LATHAN · McKEE
ARCHITECTS

ADDENDUM NO. 2
A NEW GYMNASIUM FOR OAKMAN MIDDLE SCHOOL
Architect Job No. 25-70R
November 11, 2026
DCM #2026268

JOB NO. 25-70R
SHEET NO:
A2.7
9 OF 27

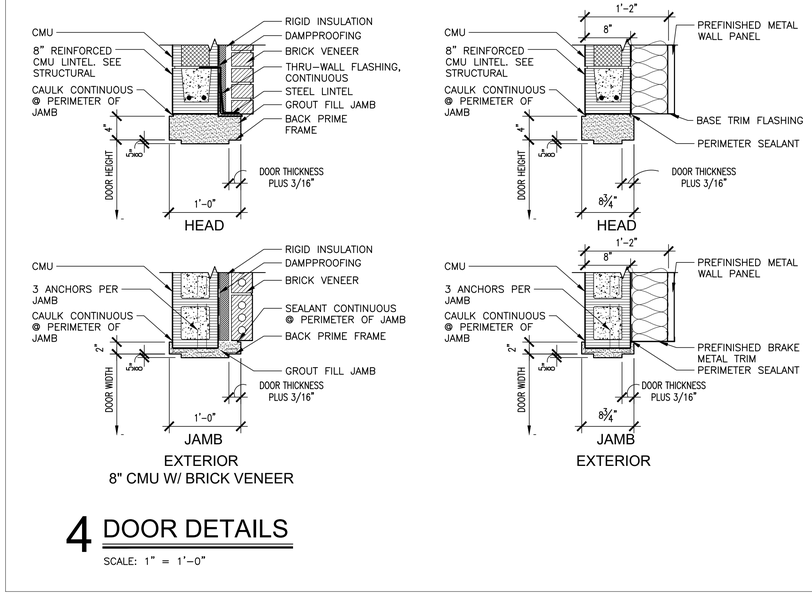
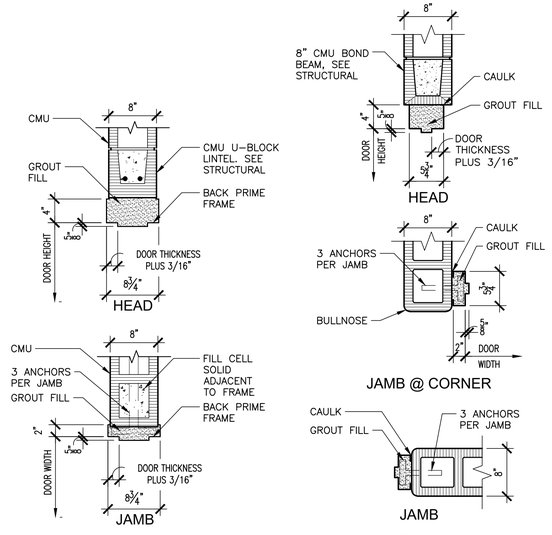
1. See **REVISED** Sheet **A2.7** – Door and Window Schedules and Details: Changed overhead door note from integral frame to surface-mounted frame
2. See **REVISED** Sheet **A3.1.2** – Exterior Elevations: 1/A3.1.2 – added note for tectum panels.
3. See **REVISED** Sheet **A3.2.1** – Building Sections: 1/A3.1.2 – added note for tectum panels.
4. See **REVISED** Sheet **P2.0** – Pressure Piping – Floor Plan: Added backflow preventer at ice machine.
5. See **REVISED** Sheet **P2.1** – Pressure Piping – Enlarged Floor Pans: Added backflow preventer at ice machine.
